Subject: [EXTERNAL] Suggestions to save trees on 5th Ave NE

5th Ave NE Trees Sidewalk Design (additional to prior letter dated 3/17/22)

RE: Smart Desgin for 5th Ave NE Sidewalks

Section View Lavout (30% Design) 5th Avenue NE

New sidewalk at 3rd Ave N and Roy St, routed around trees

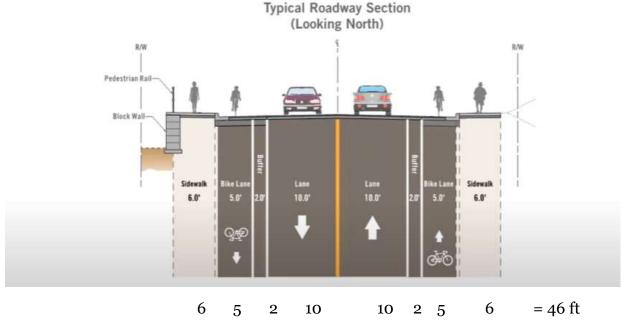
- Reduce the widths of sidewalks, bike lanes, and buffer lanes on the west side to accommodate trees/tree roots (see Boni Biery's letter 3/7/22)
- Cut-out of sidewalk, down to ADA approved 4' around the trees to save tree roots and eliminate "walls" (see photo below)
- "Permeable" sidewalk is <u>actually worse than concrete</u> as this product is "super thick" and has deeper installation with more root damage
- ADA sidewalk minimum is 4' width. Change configuration on west: 4' sidewalk, 4' bike lane, 1' buffer; East side: change buffer on east side to 1'; 4' bike lane, 6' sidewalk. The above configuration would save 6'. Eliminate wall at 5th and NE 178th.
- Discuss options with a street architect with the direction to save trees or a civil engineer experienced in saving trees.
